Skyzone JSP13-21

Consideration of the request of Mode Development, Inc., for Preliminary Site Plan and Stormwater Management Plan approval. The subject property is located in Section 9 north of Magellan Drive and east of West Road in the I-1, Light Industrial District. The subject property is 6.26 acres and the applicant is proposing to construct an 80,230 square foot building with associated parking and landscaping. Approximately half of the building will be used as an indoor trampoline center and the remaining space will be speculative office and manufacturing space.

PLAN REVIEW CENTER REPORT

Revised Preliminary Site Plan

SHEET TITLE:
 Preliminary Elevations

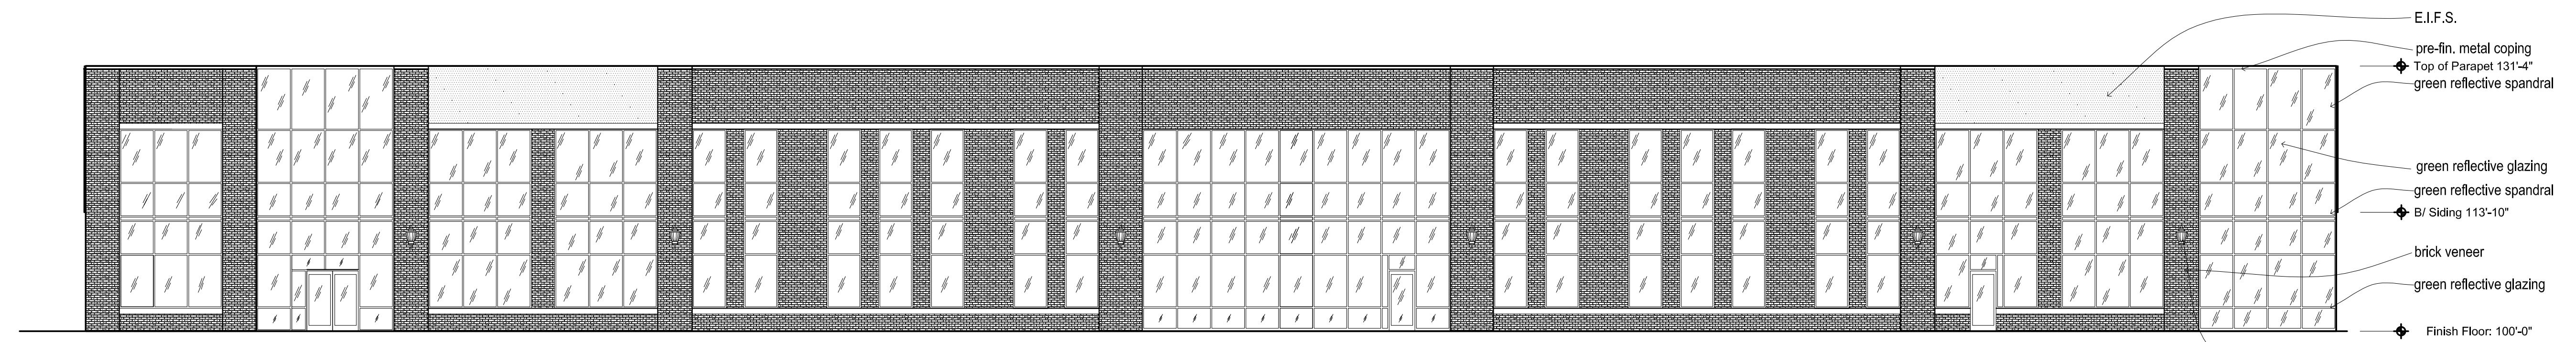
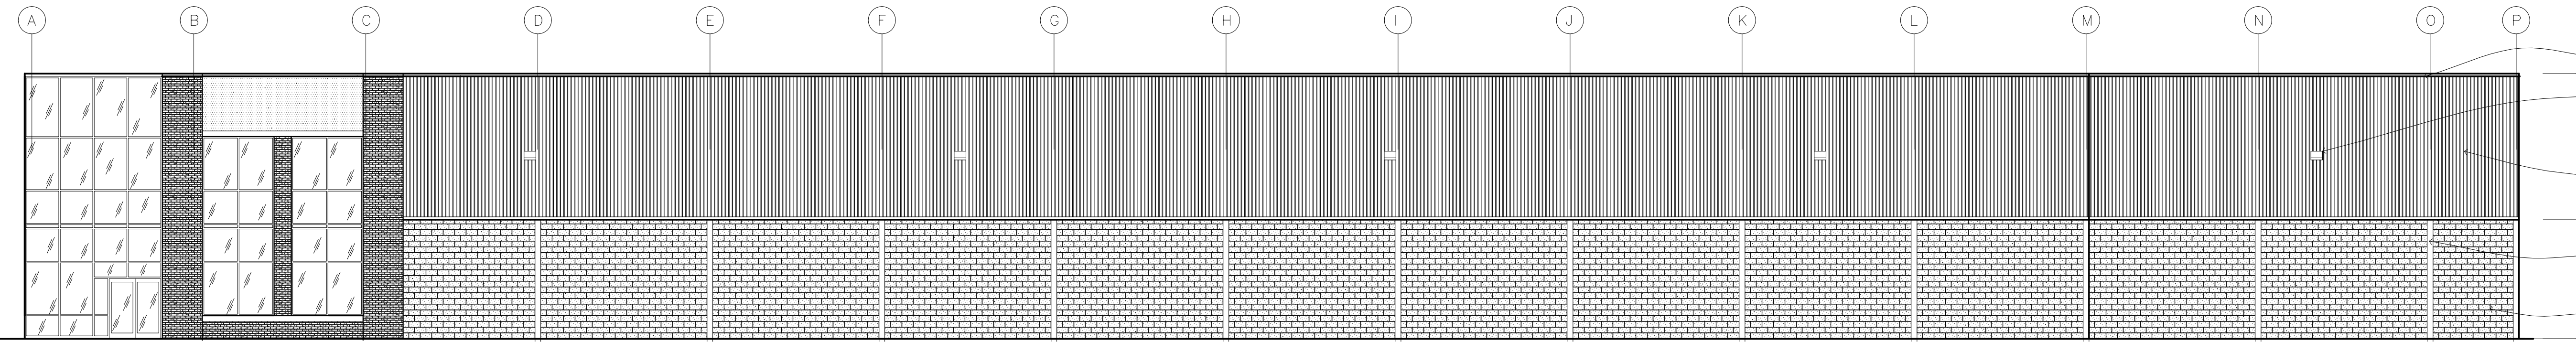
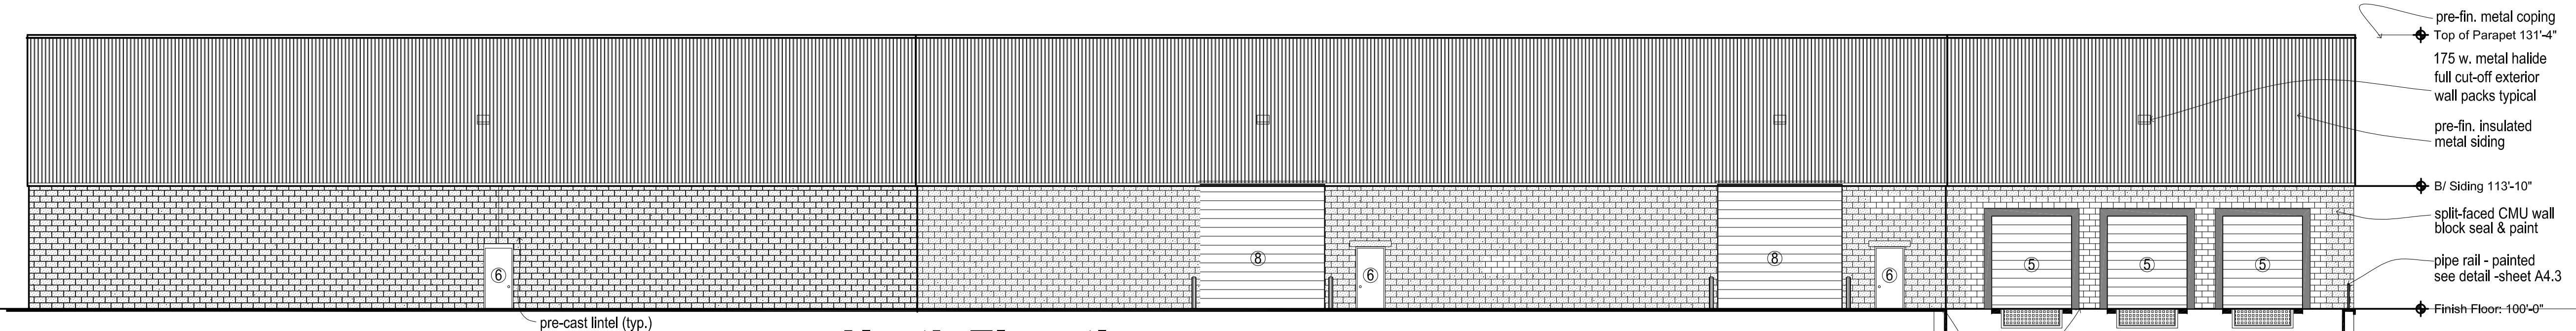
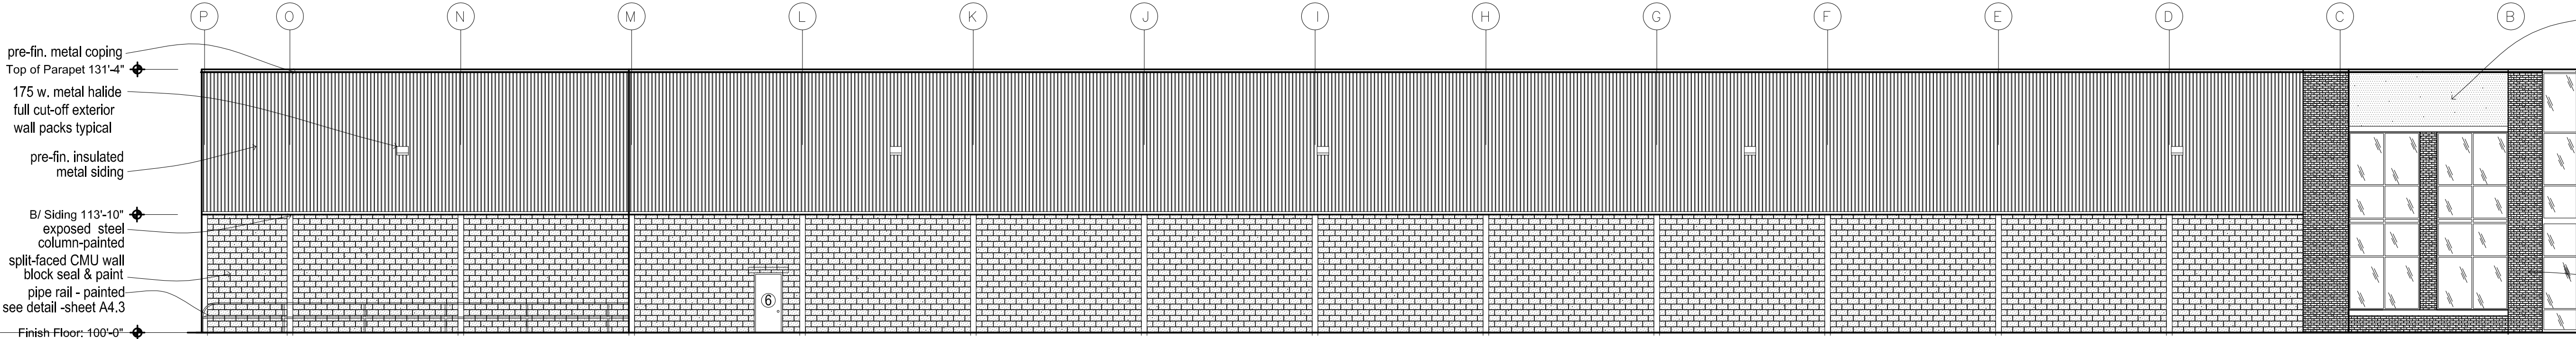
As shown above the percentage of Ribbed Metal Panels is above the maximum percentage allowed by the Façade Ordinance on the north façade. No sample board was provided for this project. Although elevation views of the dumpster enclosure were not provided the plan is noted “split faced CMU to match exterior wall if

required by city ordinance.” The applicant should note that this is required by the Façade Ordinance. The text “if required by city ordinance” should therefore be deleted from the drawing.

requested in the letter. The dumpster elevation note will be modified to indicate that enclosure will match building on the final site plan submission.

sheet title:
Landscape Improvement Plan

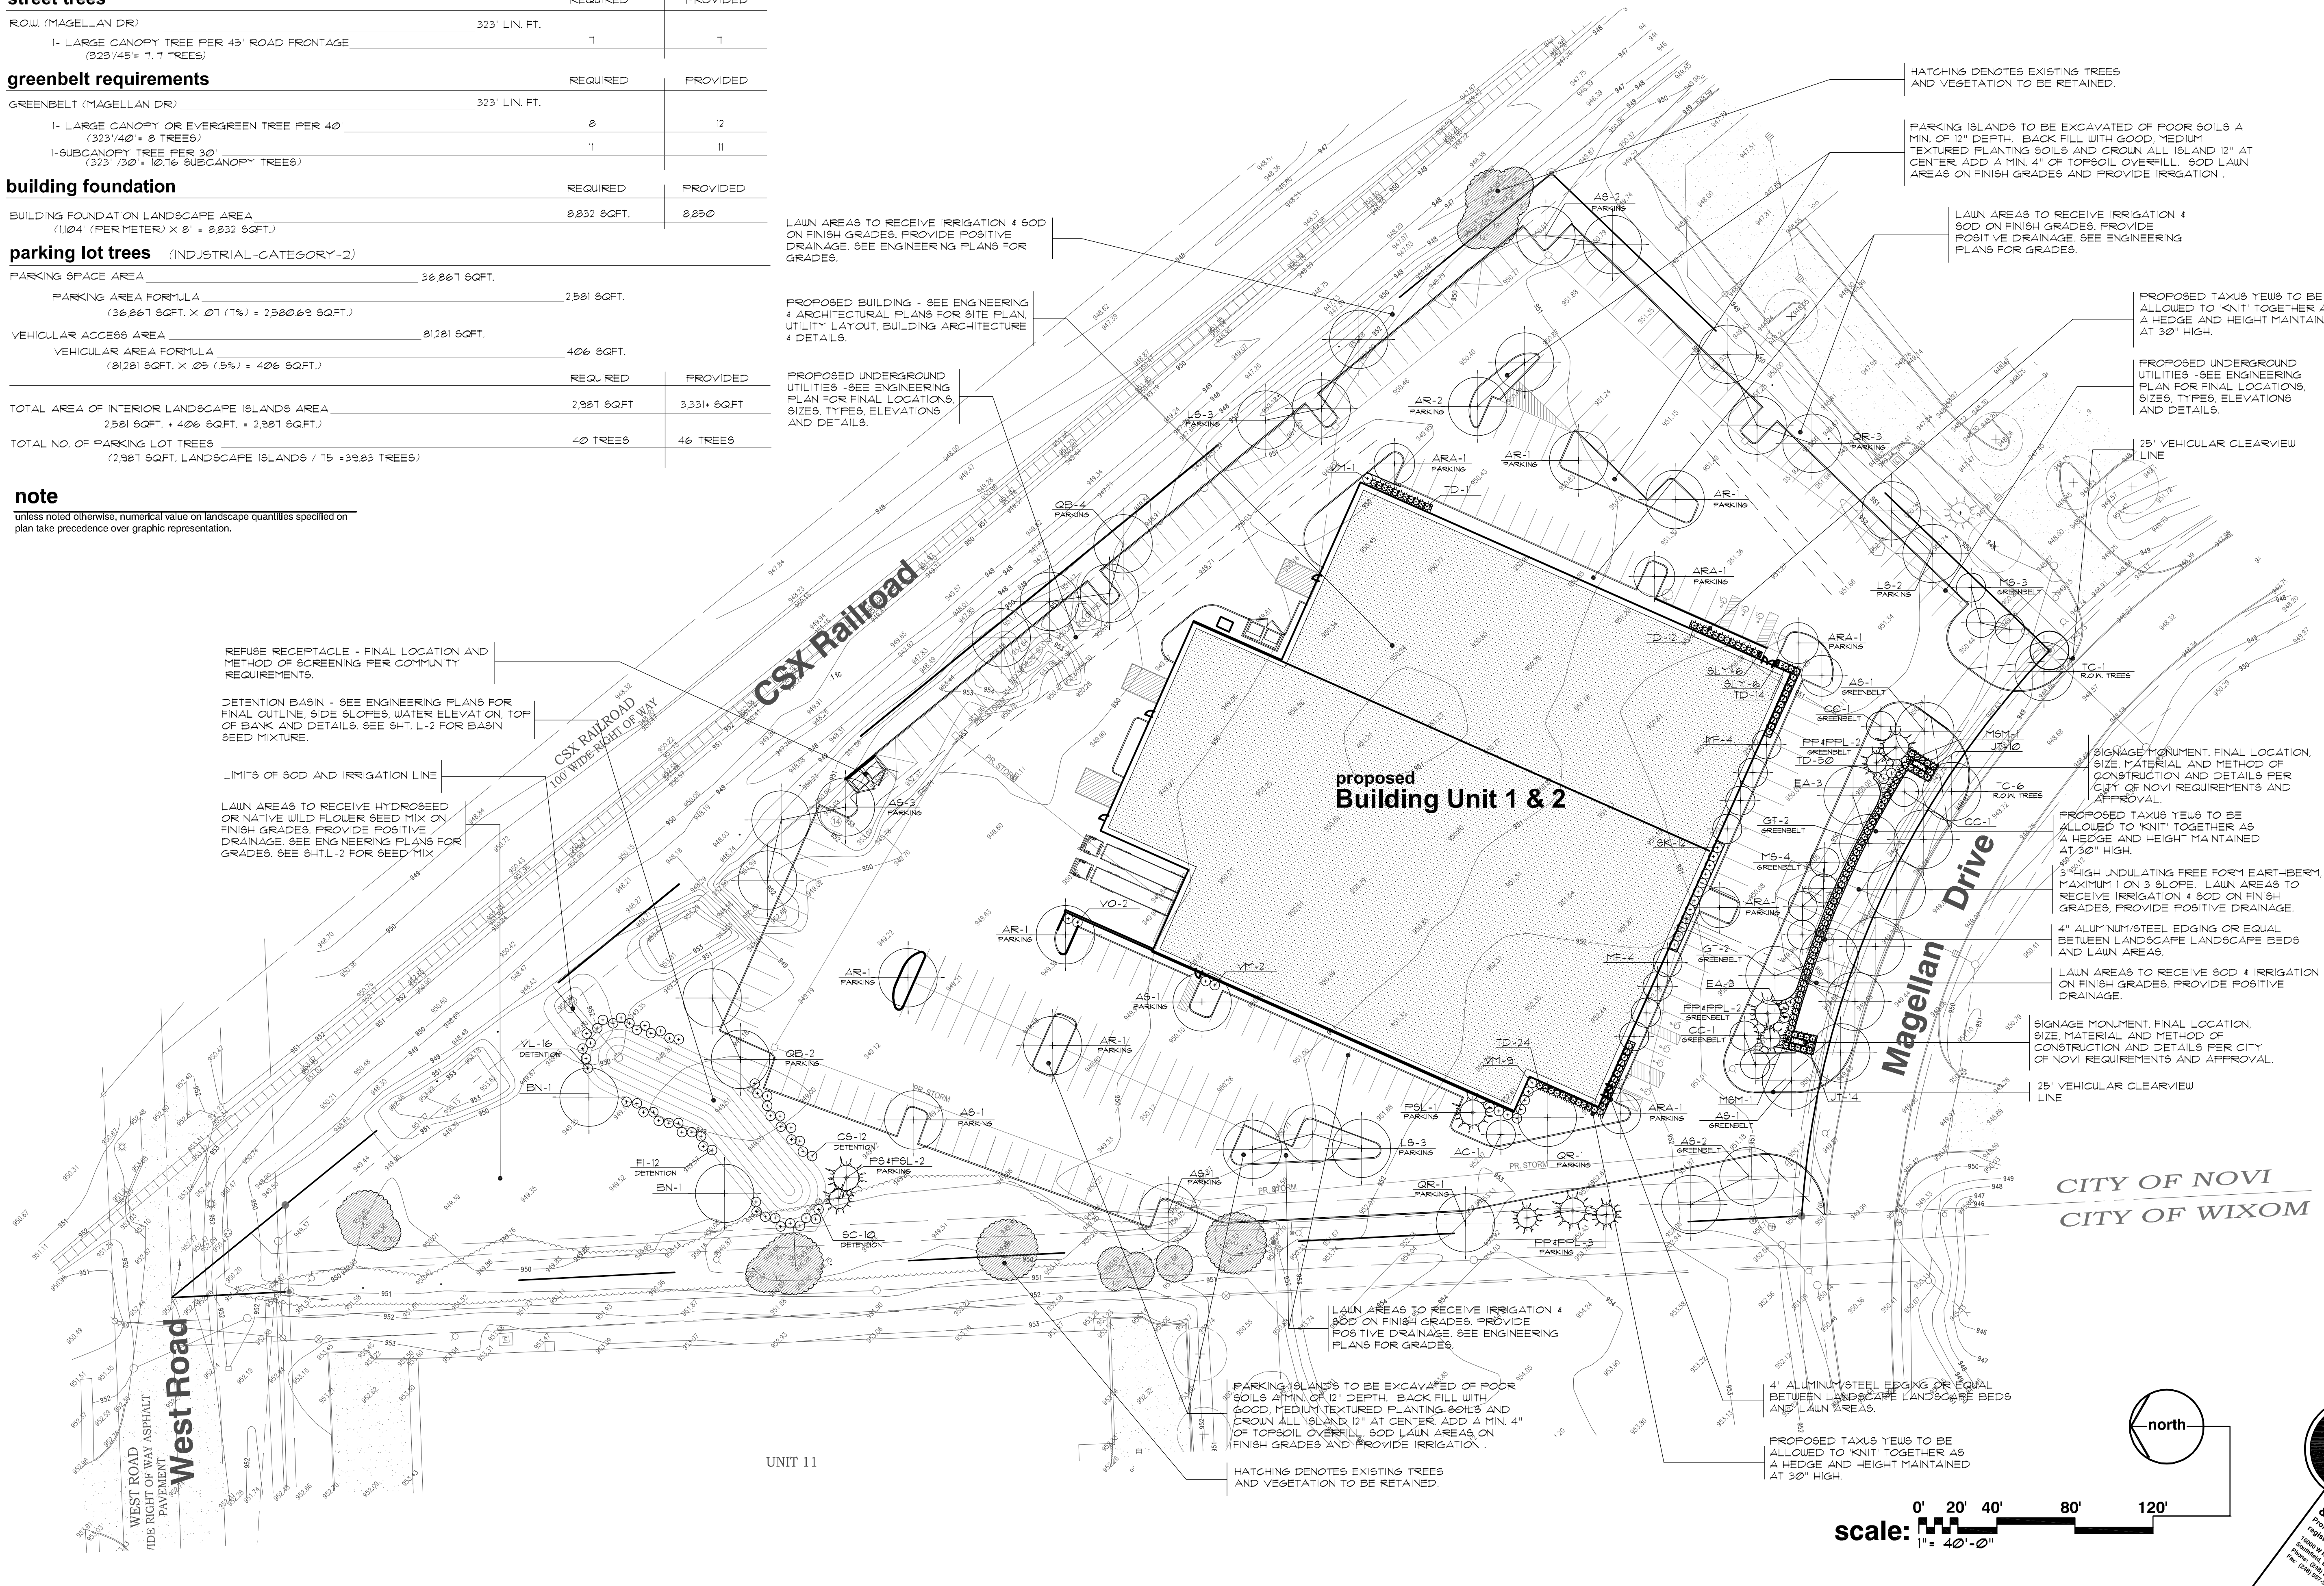
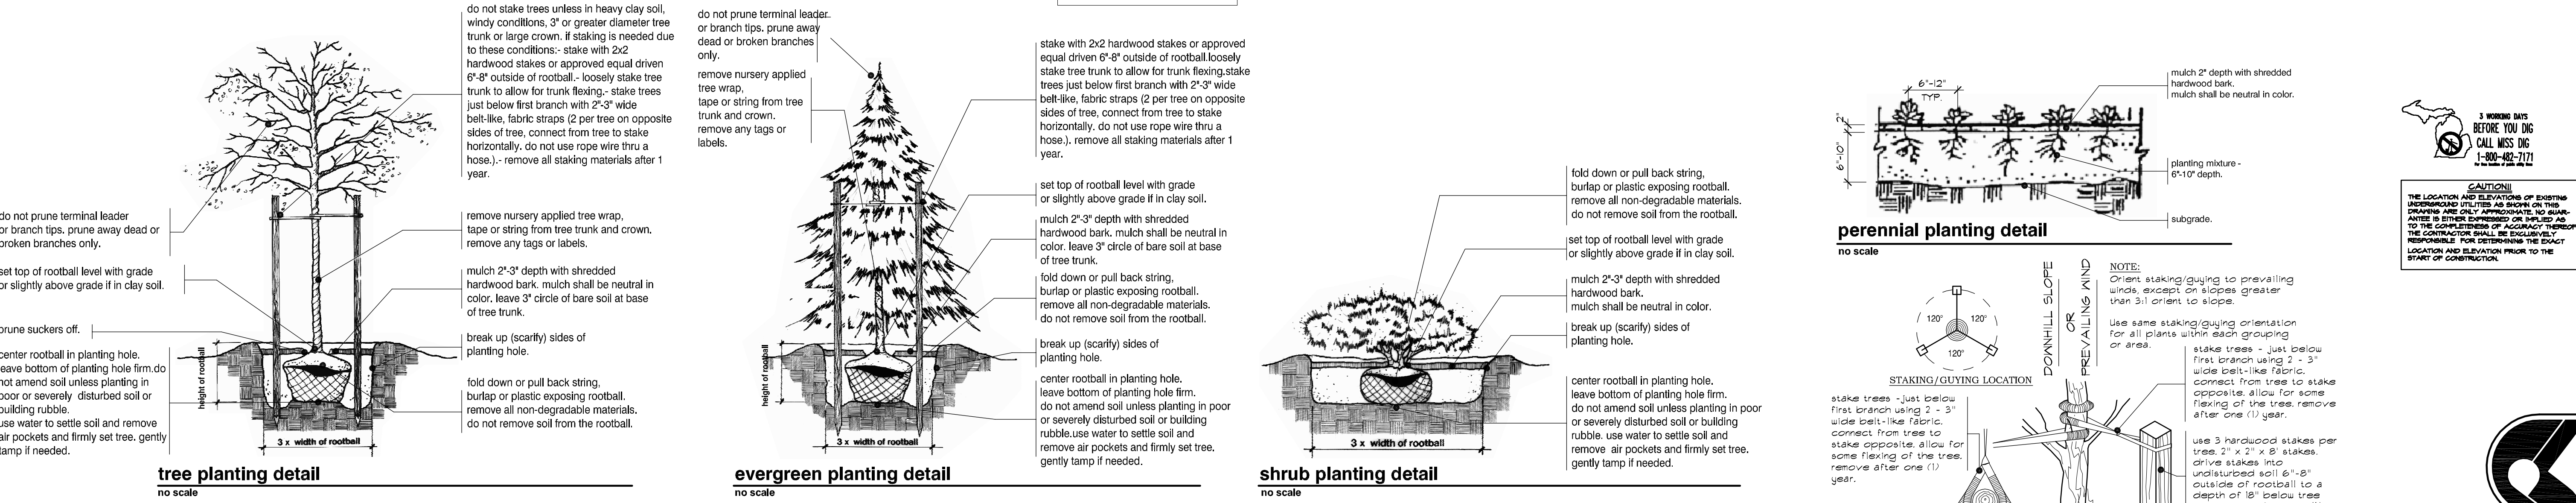
1. All landscape areas are required to be irrigated. Please provide an irrigation plan with the stamping set submittal.

The Revised Preliminary Landscape Review Letter dated July 30, 2013, recommends approval of the revised Preliminary Site Plan. As requested in the Letter, an irrigation plan will be submitted upon stamping set submittal.

SP-2

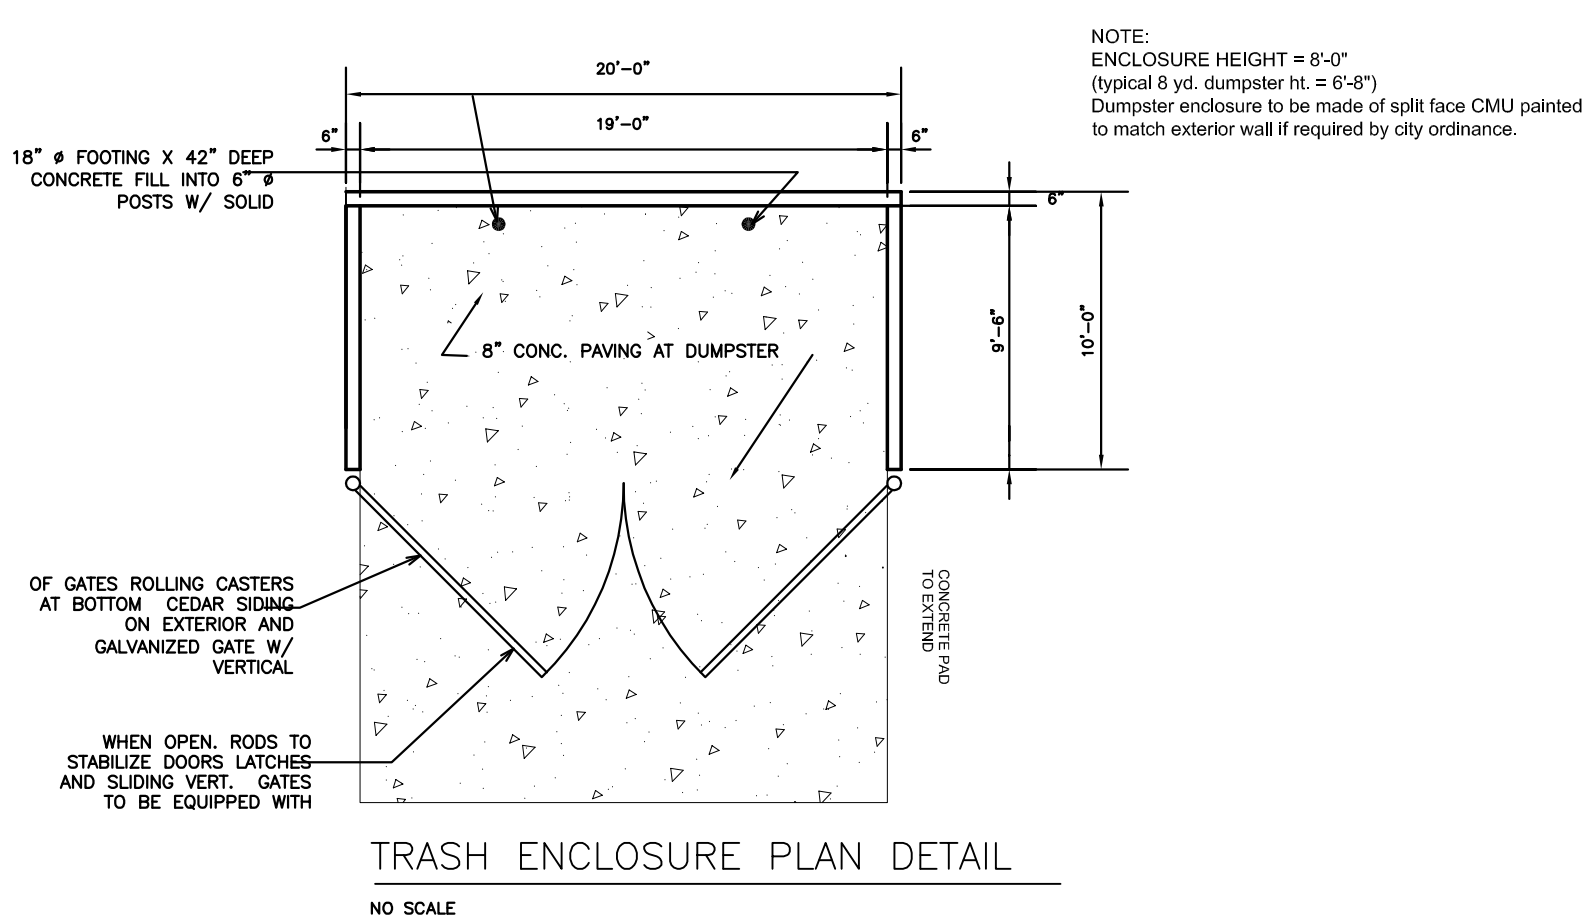
3. Dumpster Enclosure: A dumpster enclosure must be at least 1' taller than the proposed dumpster and constructed of materials to match the proposed building. **The applicant should provide a note on the plan indicating the height of the proposed dumpster.** The dumpster enclosure material must match the building façade.

3. **Dumpster Enclosure:** See revised site plan SP-2; modified as requested.
4. **Exterior Lighting:** Exterior lighting will be included with the final site plan submittal.
5. **Fire Review:** An additional hydrant was added to a parking lot island towards the east side of the building as required by Fire Marshal, Joe Shelton.
6. **Property Combination:** We are in the process of preparing documentation for parcel combination. Parcels will be combined prior to stamping set approval.
7. **Condominium Creation:** A general condominium is **NOT** intended. This is a multi-building owned by a single landlord/property manager.
8. **Signage:** Permits for exterior signage are the responsibility of the Tenant.
